Martinez Creek: Perez St to W. Huisache Ave
Solicitation Number: CO-00200
Job No.: 15-4802

ADDENDUM 2
September 27, 2018

DATE: 9/26/2018
 Sheet P-22
 53 of 115

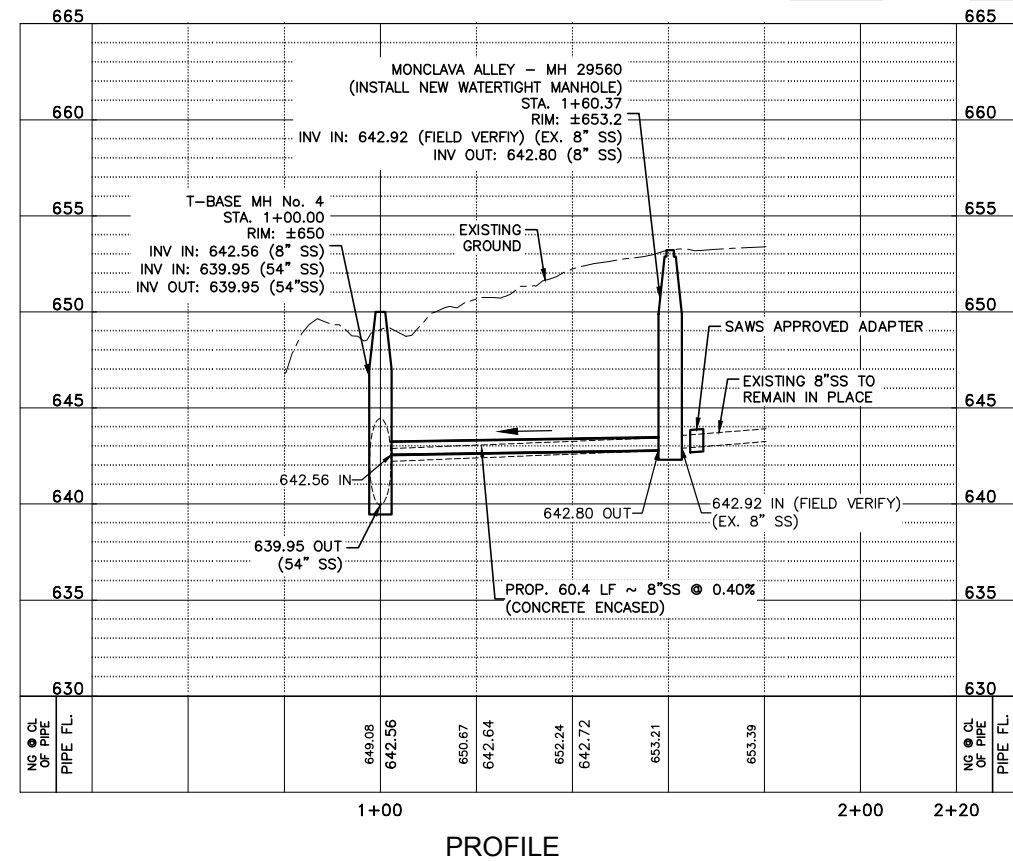
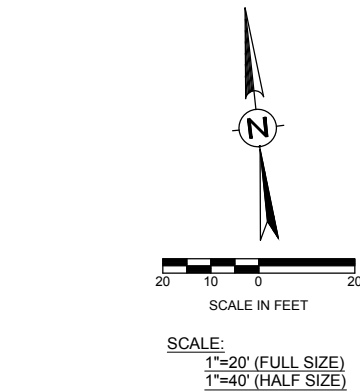
- Sheet P-22: Remove and replace Plan Sheet P-22 with the revised Plan Sheet P-22 attached to this Addendum. Sheet P-22 was revised to add the existing 4-inch gas line.

Sheet P-23

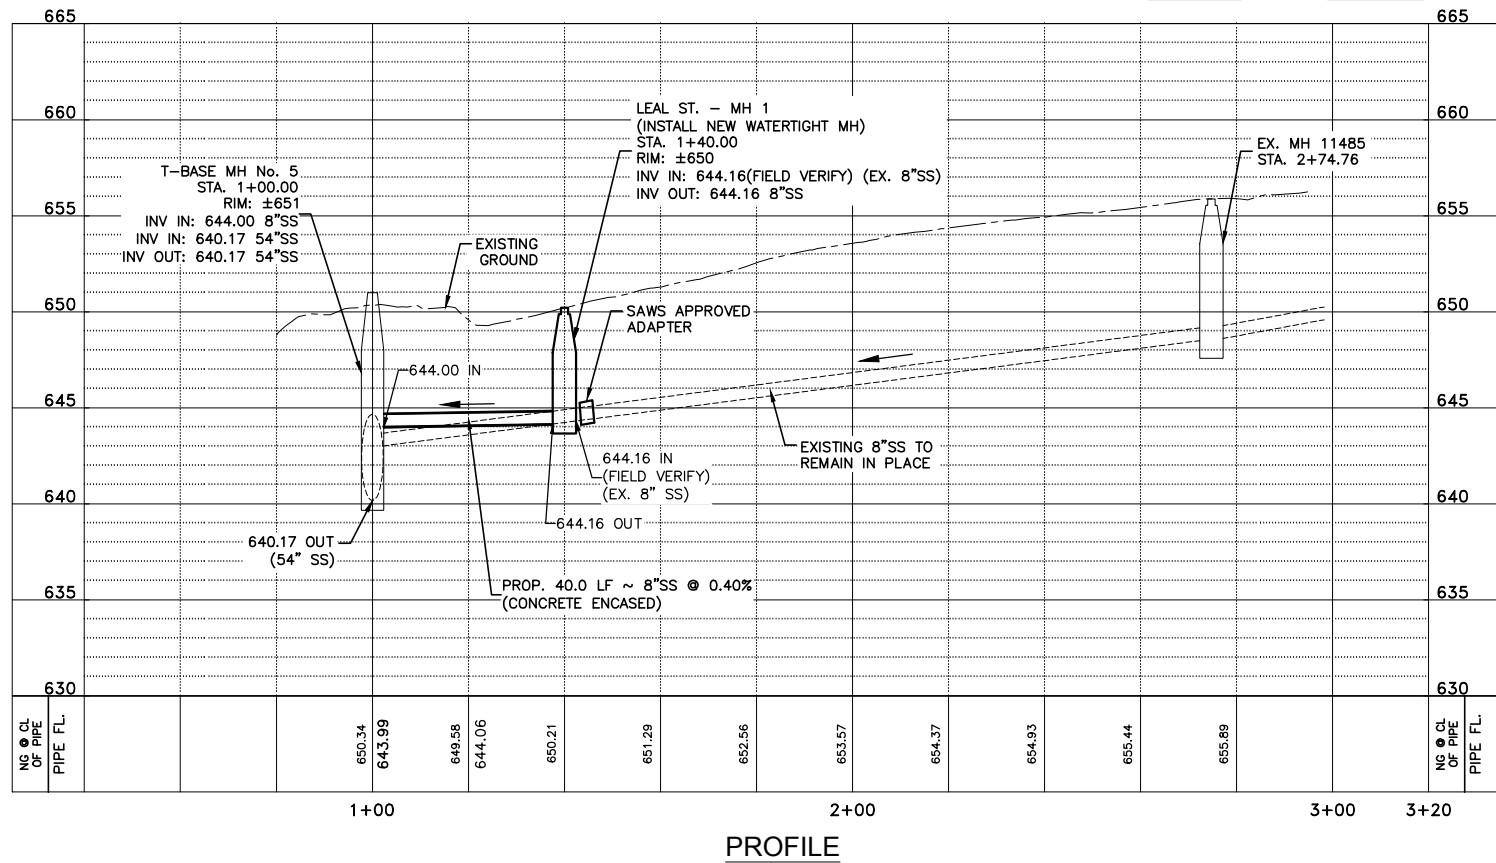
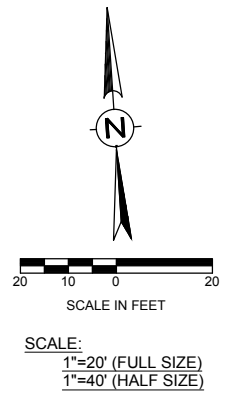
- Sheet P-23: Remove and replace Plan Sheet P-23 with the revised Plan Sheet P-23 attached to this Addendum. Sheet P-23 was revised to add the existing 2-inch gas line.

Sheet P-26

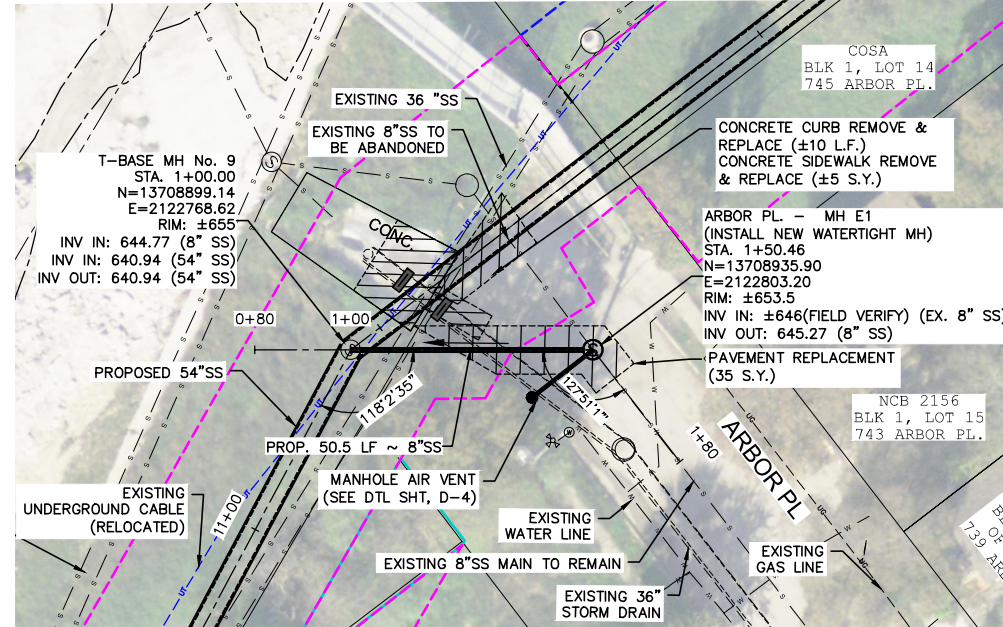
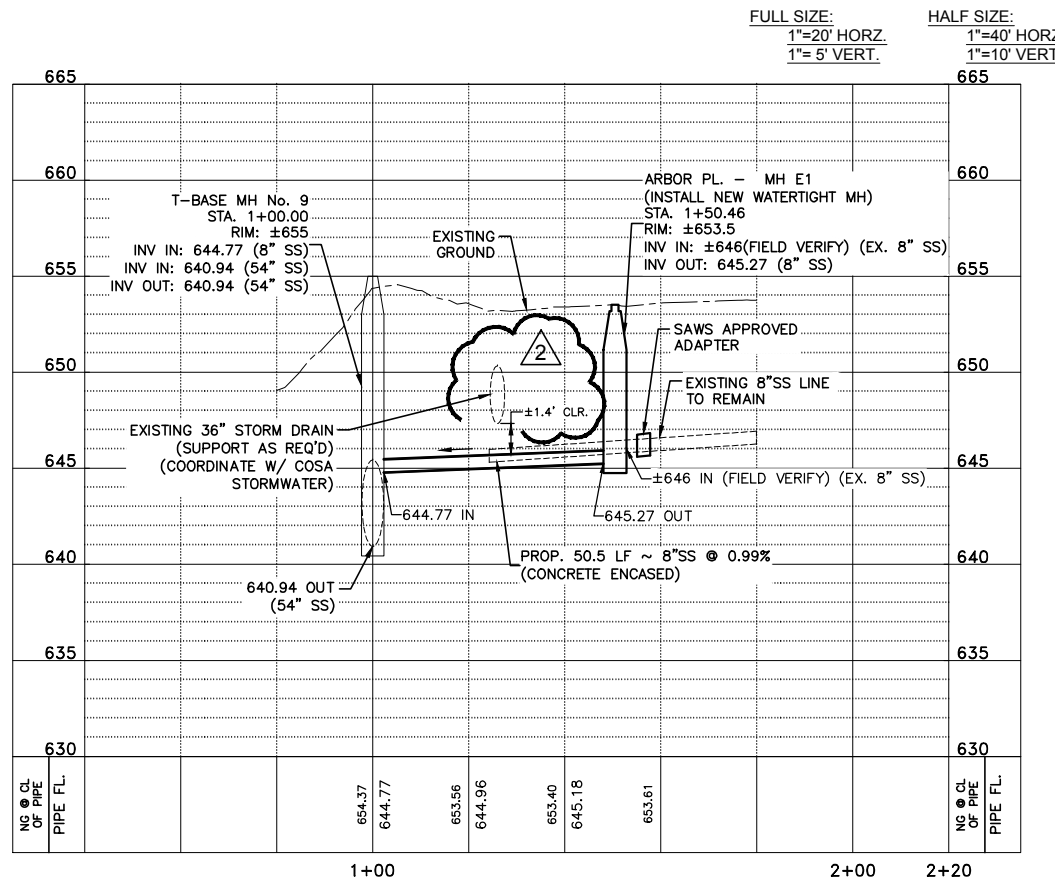
- Sheet P-26: Remove and replace Plan Sheet P-26 with the revised Plan Sheet P-26 attached to this Addendum. Sheet P-26 was revised to indicate approximate clearance between the existing 36-inch storm drain and the proposed 8-inch sanitary sewer line.

Sheet P-29

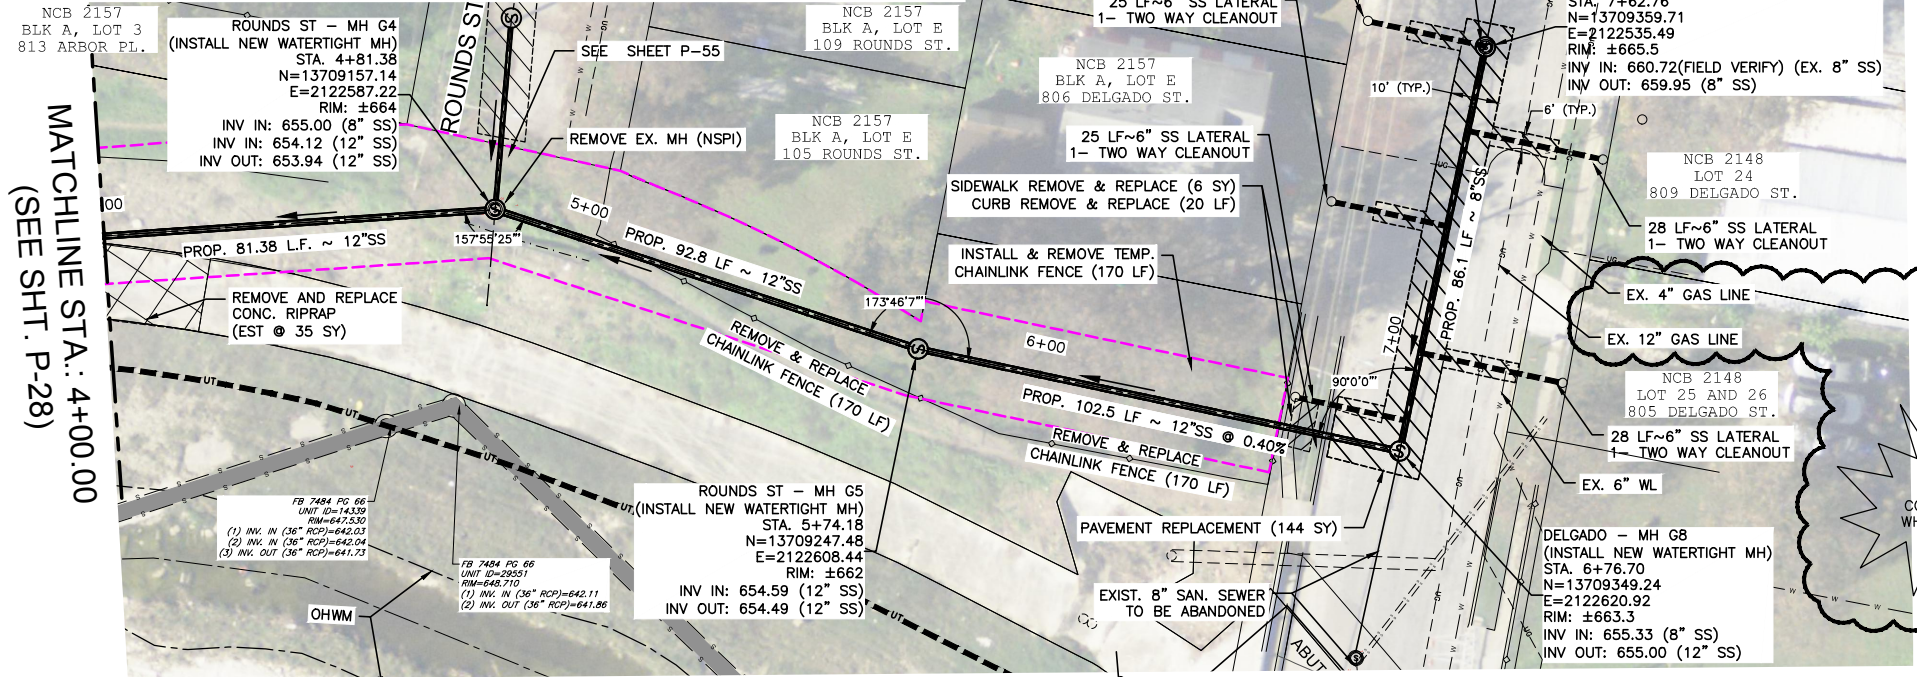
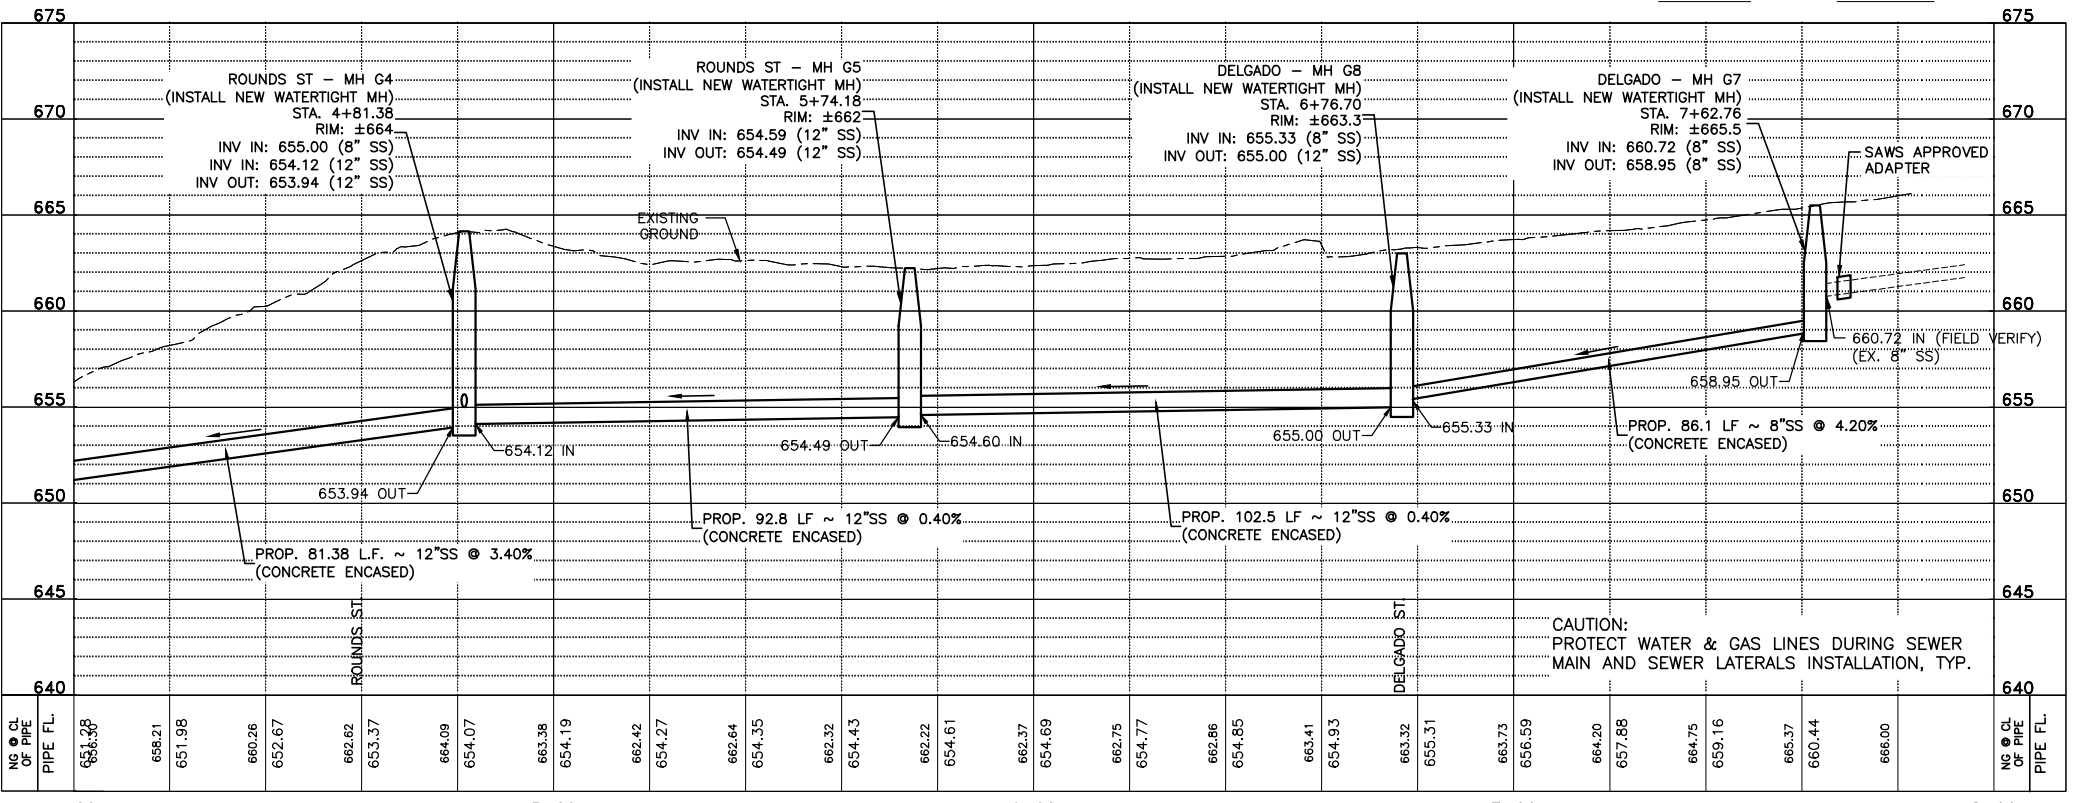
- Sheet P-29: Remove and replace Plan Sheet P-29 with the revised Plan Sheet P-29 attached to this Addendum. Sheet P-29 was revised to add the existing 4-inch and 12-inch gas lines.

Sheet P-31

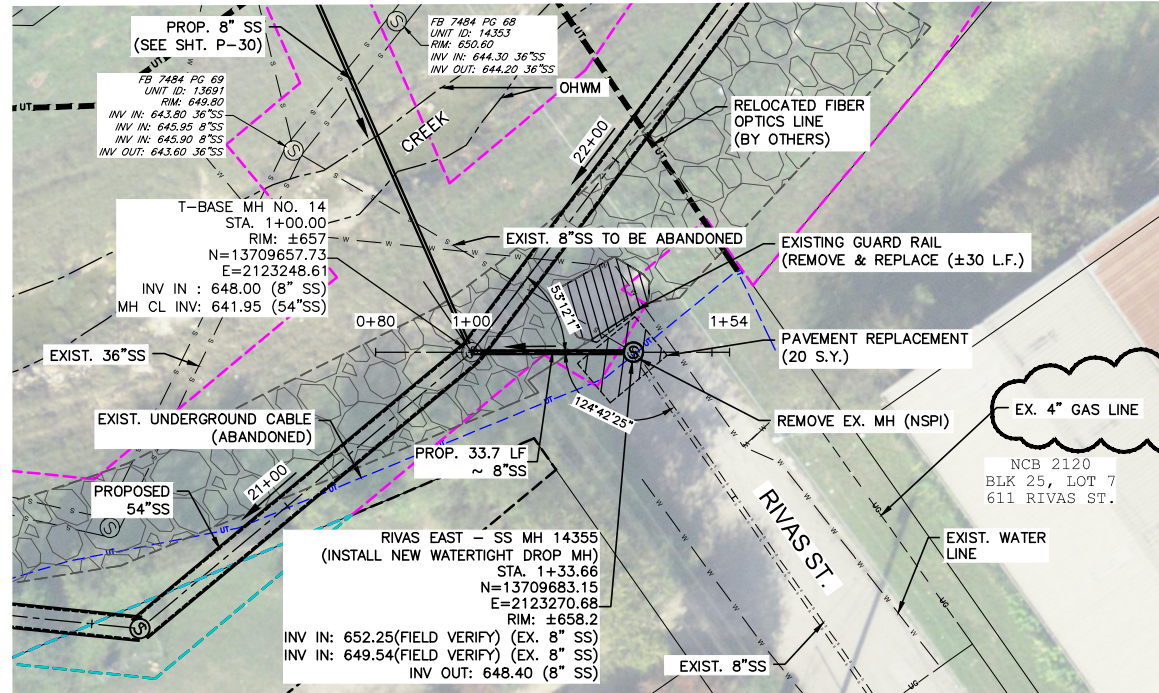
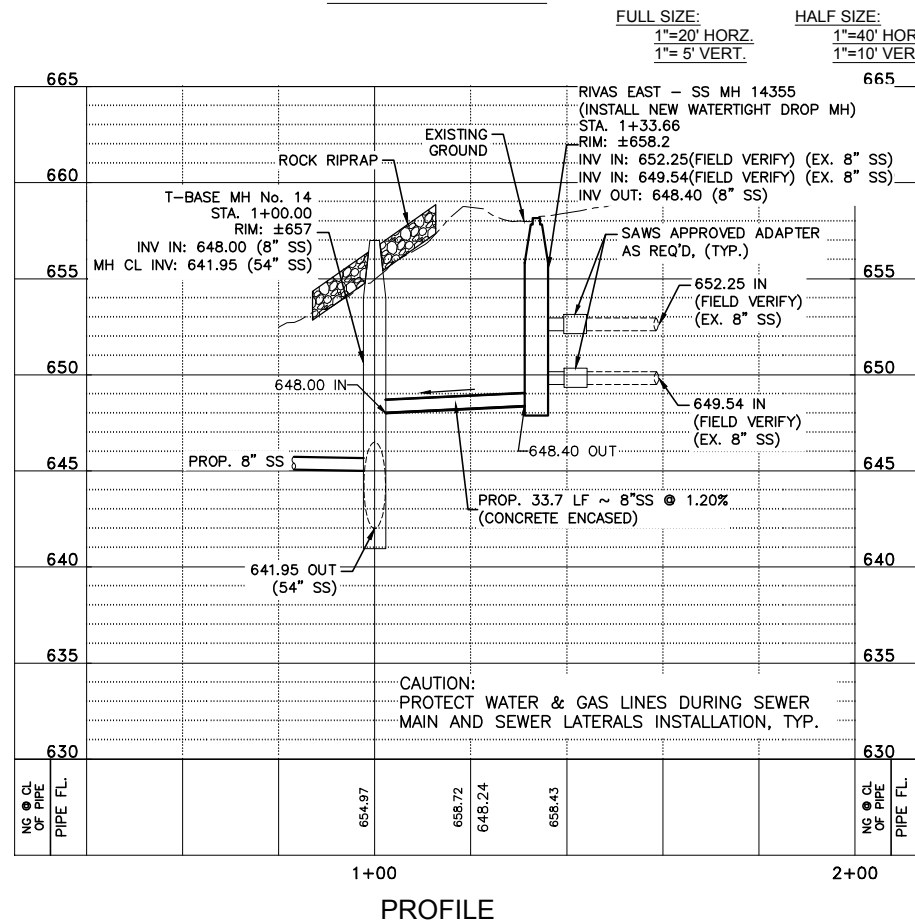
- Sheet P-31: Remove and replace Plan Sheet P-31 with the revised Plan Sheet P-31 attached to this Addendum. Sheet P-31 was revised to add the existing 4-inch gas line.

Sheet P-32

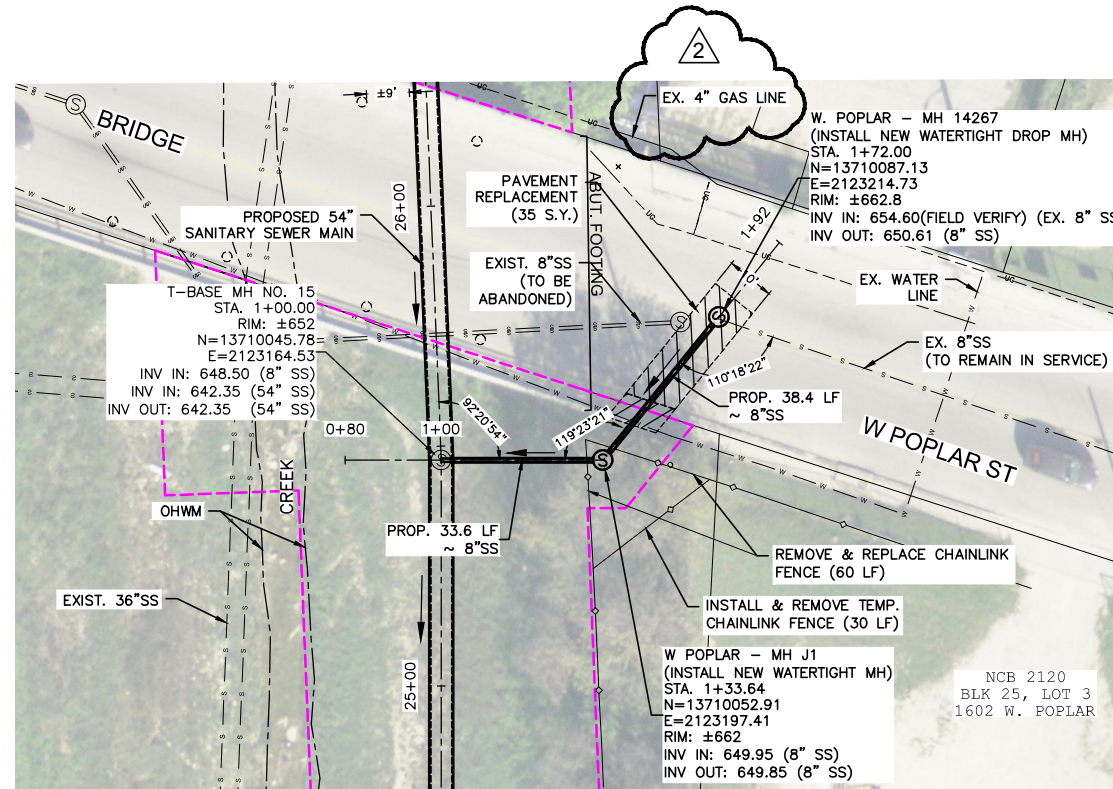
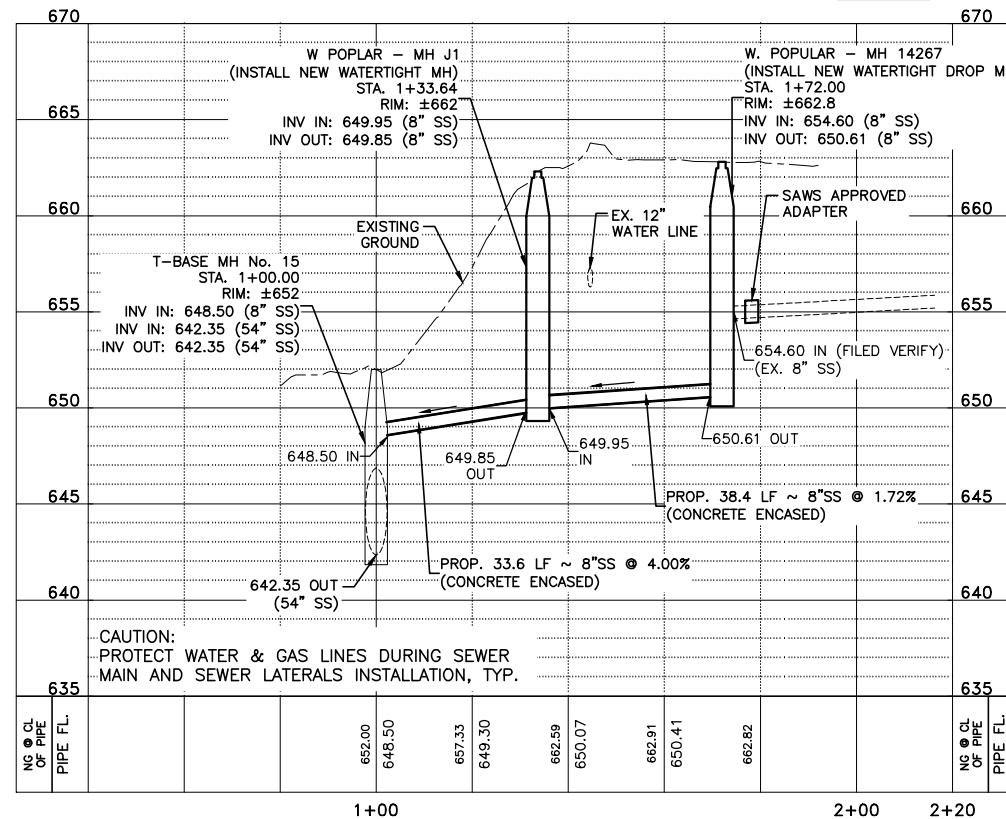
- Sheet P-32: Remove and replace Plan Sheet P-32 with the revised Plan Sheet P-32 attached to this Addendum. Sheet P-32 was revised to add the existing 4-inch gas line.
